**Historical Architectural Review Board
COA Final Review Sheet**

HDC-2023-00042

Address: 44 N. West Street

Proposal: Construct masonry wall in side yard

Rendering of proposed site wall.
(Applicant)

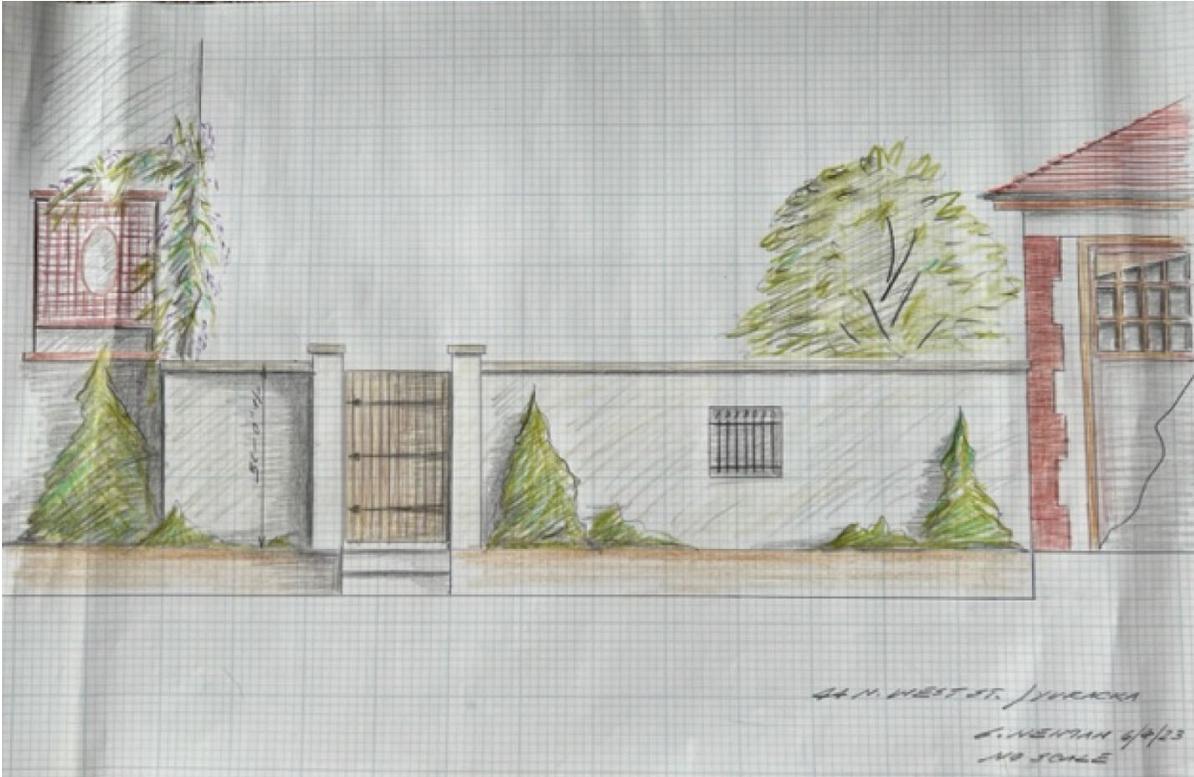
Staff finds the proposed work satisfies the intent of the design guidelines since the masonry wall would match the height of the existing fence and other nearby fences along West Street, complying with Guideline 3.12.7. The wall would be low enough, at a maximum height of 6-feet, so as not to obscure views of the building and would have no impact on the primary façade. The site wall would also comply with Guideline 3.12.12, since it would be constructed of masonry materials and finished to match the historic structure.

The proposed gate is illustrated as being wood with metal strap hinges and is appropriate in material and design.

For final approval, staff recommends that the applicant submit specs and/or cut sheets on the stucco/finish of the wall, cap, and gate.

Approval, with the staff to review details, pursuant to Chapter 3, Section 3.12 Fences & Streetscape Features and the Secretary of the Interior's Standards for Rehabilitation.
